Product/Process Change Notice (PCN)	
<input type="checkbox"/> Major Change <input checked="" type="checkbox"/> Minor Change	
PCN Number: PCN_PeBUTR_20250204 Affected Series: WP-BUTR Affected Part Number: 7460553 PCN Date: 2024-11-04 (YYYY-MM-DD) Effective Date: 2025-02-04 (YYYY-MM-DD)	Change Category: <input type="checkbox"/> Equipment/Location <input checked="" type="checkbox"/> General Data <input type="checkbox"/> Material <input type="checkbox"/> Process <input type="checkbox"/> Product Design <input checked="" type="checkbox"/> Shipping/Packaging <input type="checkbox"/> Supplier <input type="checkbox"/> Software
Contact: Product Management Phone: +49 (0) 7942 - 945 5001 Fax: +49 (0) 7942 - 945 5179 E-Mail: pcn.eican@we-online.com	Datasheet Change: <input checked="" type="checkbox"/> Yes <input type="checkbox"/> No Attachment: <input type="checkbox"/> Yes <input checked="" type="checkbox"/> No

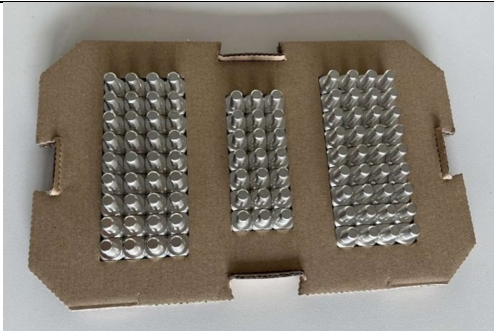
DESCRIPTION OF CHANGE: <p>Due to an improvement of the production capability, Würth Elektronik eiSos will change the packaging from carton to carton tray. The new carton will change the SPQ an CPQ.</p> <p>In addition, because of database mismatch the value of the total height is placed in brackets.</p> <p>There will be no change in form, fit, function, quality or reliability of the product.</p> <p>The new revision of the affected order codes will be sent out after the previous revision is out of stock (according to FIFO - first-in, first-out).</p>	
DETAILS OF CHANGE: <p>The new packaging will look like showed in the pictures below.</p>	
Before Change	After Change

Dimensions (LxWxH):	Dimensions (LxWxH):
139.0 x 89.0 x 97.0 mm	274.0 x 171.0 x 15.0 mm

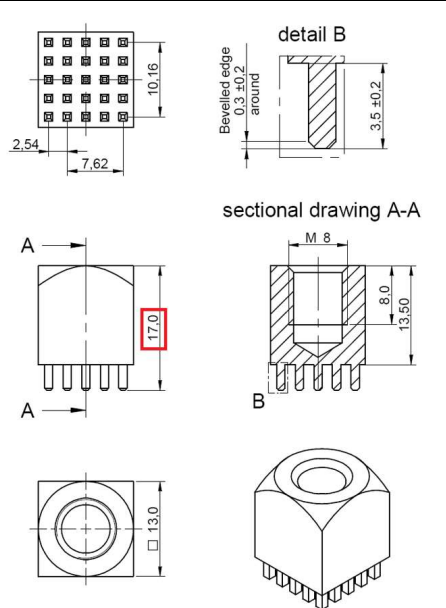
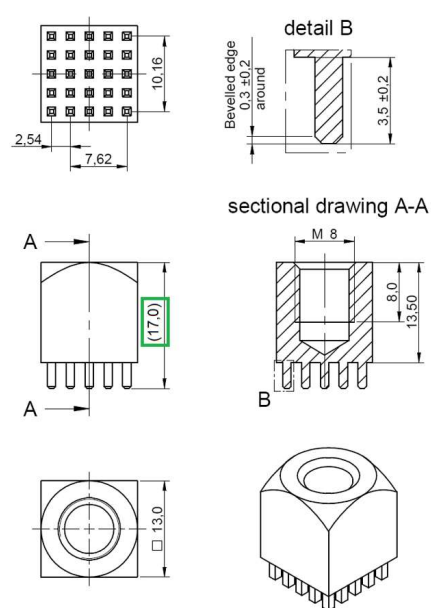
Dimensions (LxWxH): 300.0 x 200.0 x 115.0 mm		Dimensions (LxWxH): 300.0 x 200.0 x min. 115.0 mm Height varies depending on the component due to two-part carton.		
Before Change		After Change		
General Information:		General Information:		
Material	Brass	Material	Brass	
Surface	Tin	Surface	Tin	
Execution	Press-Fit	Execution	Press-Fit	
Operating Temperature	-55 up to +150 °C	Operating Temperature	-55 up to +150 °C	
Packaging	Bulk	Packaging	Tray	
Order Code	Before Change		After Change	
	SPQ: Carton case	CPQ: Carton	SPQ: Carton Tray	CPQ: Carton
7461059	96	-	93	465
